## Tom's Bar & Grill JSP13-45

Public hearing at the request of Tom P LLC #6 for Preliminary Site Plan utilizing the Retail Service Overlay option, Special Land Use Permit, Wetland Permit, Woodland Permit and Stormwater Management Plan approval. The subject property is 1.88 acres in Section 16 of the City of Novi and located at 27200 Beck Road at the southeast corner of Citygate Drive and Beck Road in the OST, Planned Office Service Technology District. The applicant is proposing a 5,700 square foot sit-down restaurant.

## PLAN REVIEW CENTER REPORT

**SUBJECT: Tom's Bar & Grill, JSP13-0045, Traffic Review of Preliminary Site Plan, PSP13-0105**

**Alternative A: Flat Parking Surface with Sidewalk Ramped - Wheel Stops Not Required**

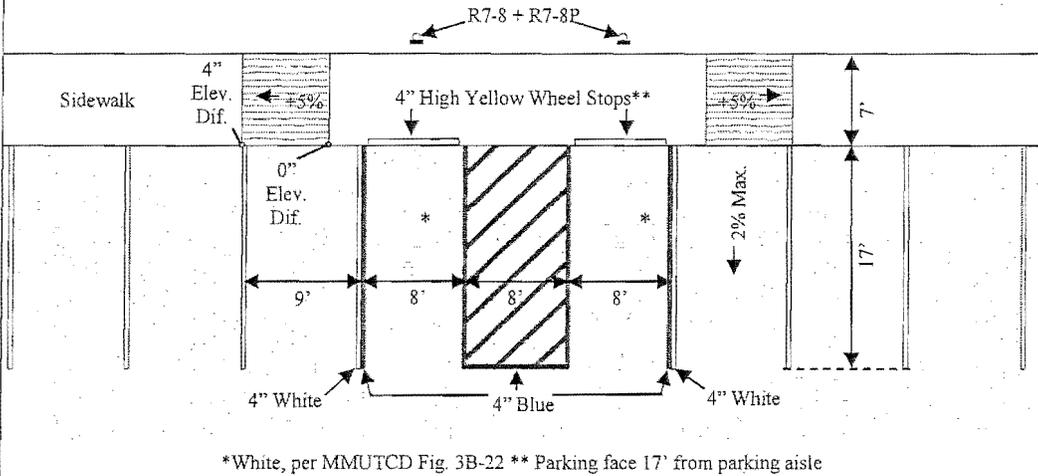
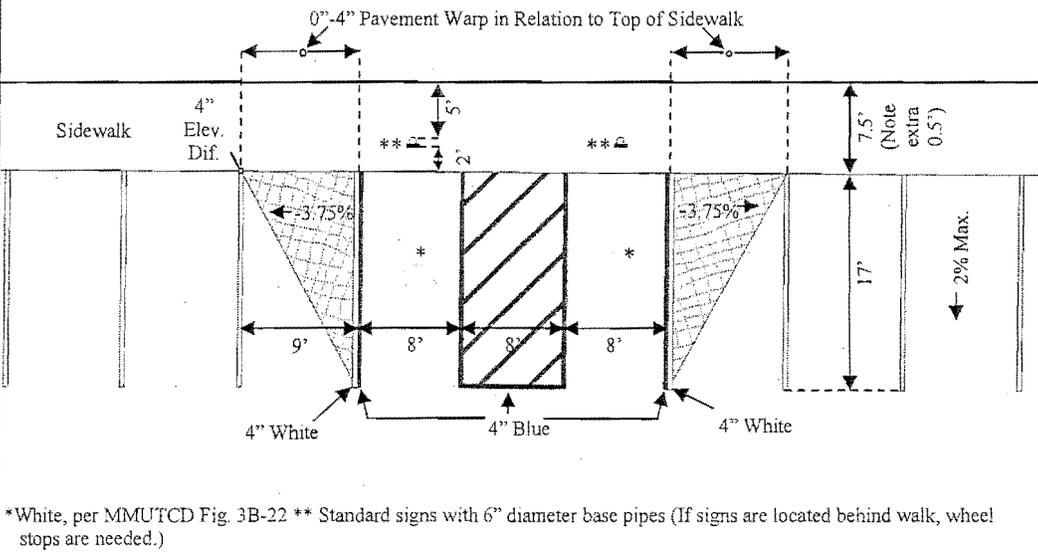
11. The overall circulation design is satisfactory.
12. The parking design along the building's east façade has been revised since the pre-application plan, and not all revisions are acceptable. In the process of adding the bumper blocks we recommended at the ends of the two interior barrier-free parking spaces, the applicant chose to narrow the sidewalk to 5 ft from the previously proposed 7 ft (although architectural sheet 12-05 still shows a 7-ft-wide walk). Unfortunately, this narrowing of the walk would result in overhanging parked cars significantly restricting the usable walk width, in some cases to as little as 3 ft (drivers would not necessarily stop short of the walk just because their space has been lengthened to 19 ft). **The sidewalk should remain 7 ft wide and 4 inches high; the abutting spaces 17 ft long to the face of walk or blocks; and the bumper blocks located on the edge of the flush walk and not on the parking surface, such that the blocks' east faces align with the east face of walk (see our attached examples of acceptable barrier-free parking design).**

9. Additional sidewalk connection will be provided on the final site plan.
10. The applicant will provide funds in an escrow account for the extension of the sidewalk along the Citygate Drive frontage to the eastern property line for the sidewalk to be constructed at a future date.
12. A 7 foot sidewalk will be provided along the building's east façade on the final site plan.
13. Plan notes regarding traffic signing and striping requirements will be revised per the review letter on the final site plan.
14. Loading zone details will be revised per the review letter on the final site plan.

Title:  
**Site Plan**

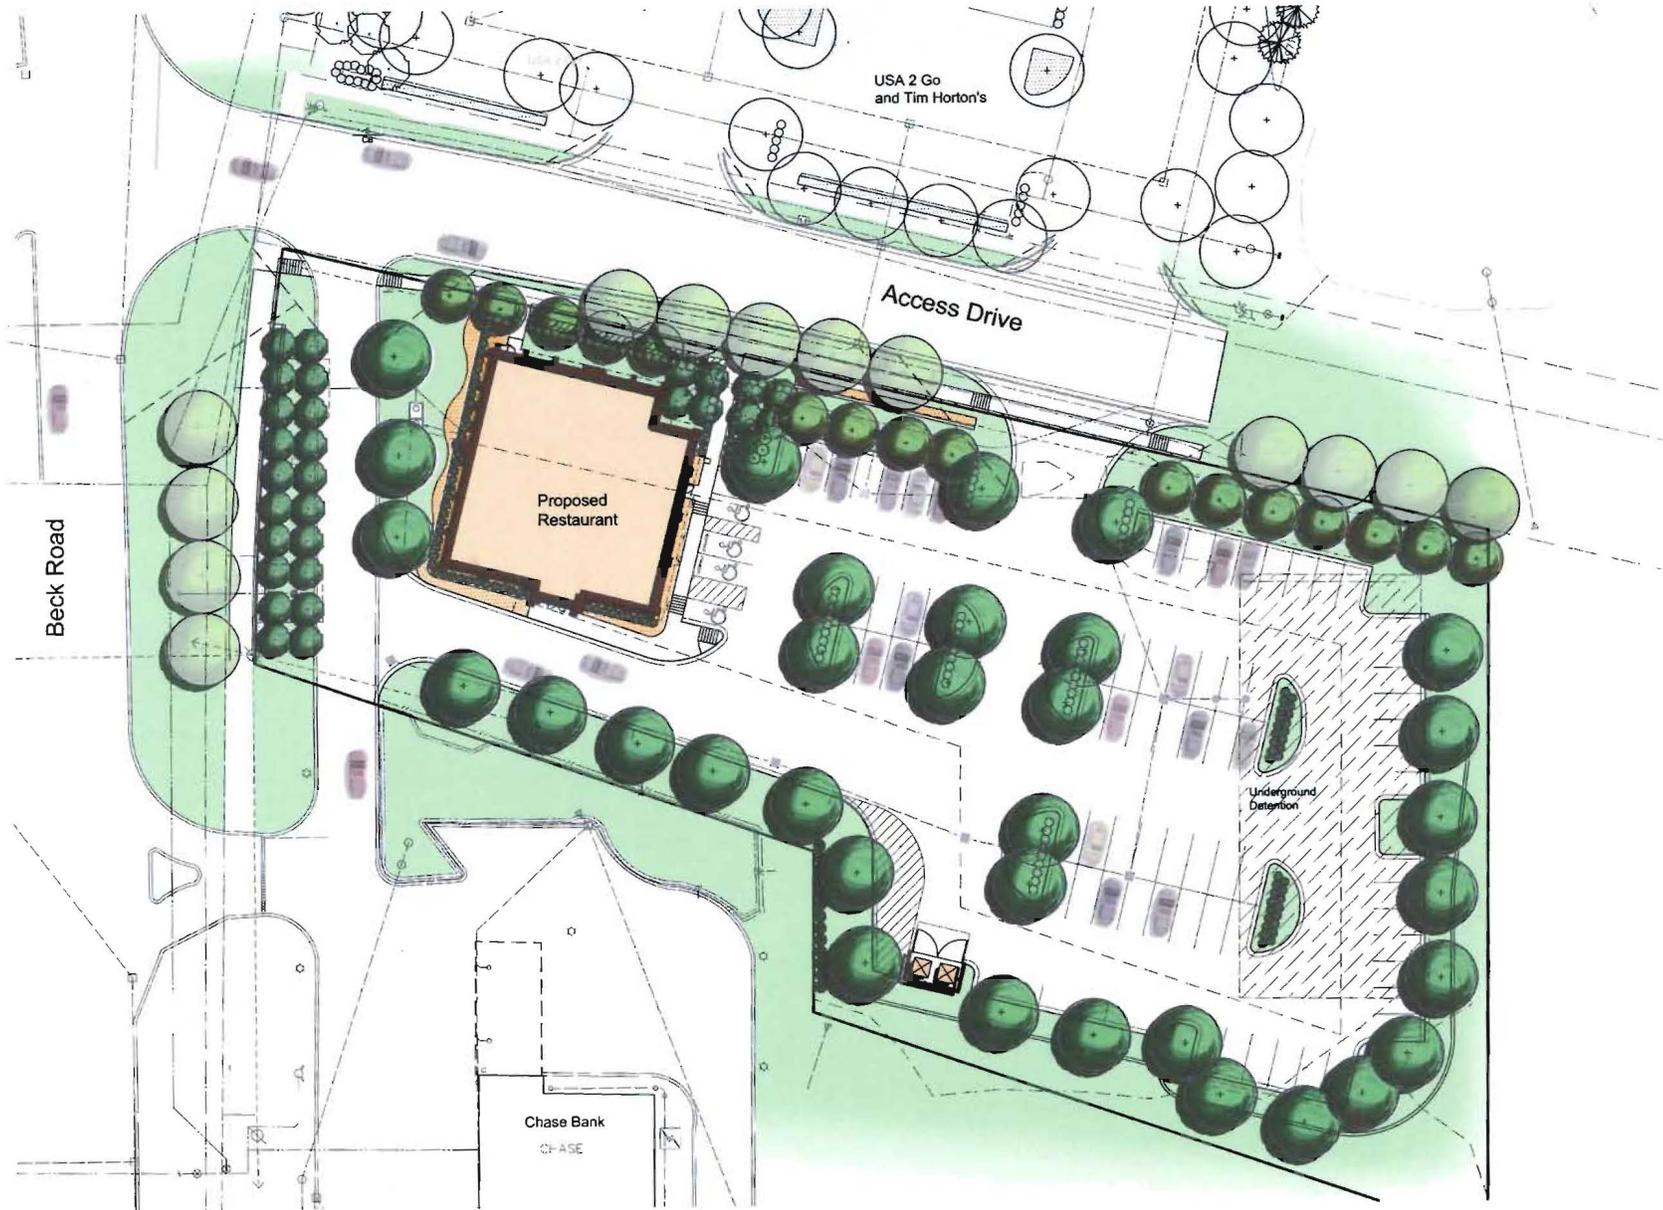
2. Building Setbacks: Buildings in the OST District must be setback 50 feet from all property lines. The plan indicates a 15 foot building setback in the northern yard. **The applicant has indicated they will seek a variance from the Zoning Board of Appeals for this deficiency.**

4. Parking Space Dimensions: A 7 foot sidewalk is required in areas adjacent to 17' parking spaces. **The applicant should include a 7 foot sidewalk adjacent to the proposed barrier free spaces.**

5. Sidewalks: The 5 foot sidewalk proposed along Citygate Drive does not extend to the eastern property line. A sidewalk is required along this entire road frontage. Citygate Drive has not been extended to the subject property's eastern-most border at this time. **The applicant should either extend the sidewalk to the eastern property line or provide funds in an escrow account for the extension of the sidewalk at a future date.** See the traffic review letter for additional information.

1. **Retail Service Overlay**: A public hearing is hearing is scheduled for Wednesday July 10, 2013.
2. **Building Setbacks**: The applicant will seek a variance from the Zoning Board of Appeals for the proposed 14.85 feet northern yard building setback.
4. **Parking Space Dimensions**: A 7 foot sidewalk will be provided adjacent to the proposed barrier free spaces on the final site plan.
5. **Sidewalks**: The applicant will provide funds in an escrow account for the extension of the sidewalk along the Citygate Drive frontage to the eastern property line for the sidewalk to be constructed at a future date.
